**What's New** (Specific text highlighted):

E-Series	Model Description
F39	X2 Sports Activity Coupe
F44	2 Series Gran Coupe
F48	X1 Sports Activity Vehicle

Customer complains of musty odor or damp front footwell carpet.

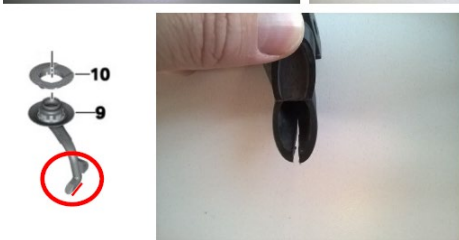
<p>3. This close up shows drain incorrectly installed.</p>
	<p>4. Water leaks can occur in these areas causing the molding smell from carpet.</p>
	<p>5. Remove brackets (1) and heat shield screws (2) and (3).</p>

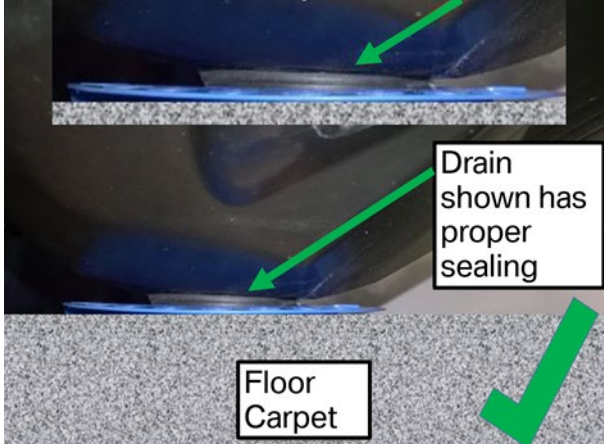
6. Remove the clamp and support exhaust to expose the drain.

7. Prepare new drain by cutting the lower section approximately 30 mm. This will prevent future blockage.

8. Before installing new drain, lubricate (silicone spray) top of drain shown by the yellow ring. Make sure the drain is not deformed and install parallel to the floor and carpet.

<p>9. A correct drain installation is shown. Install all removed parts.</p>
---	---
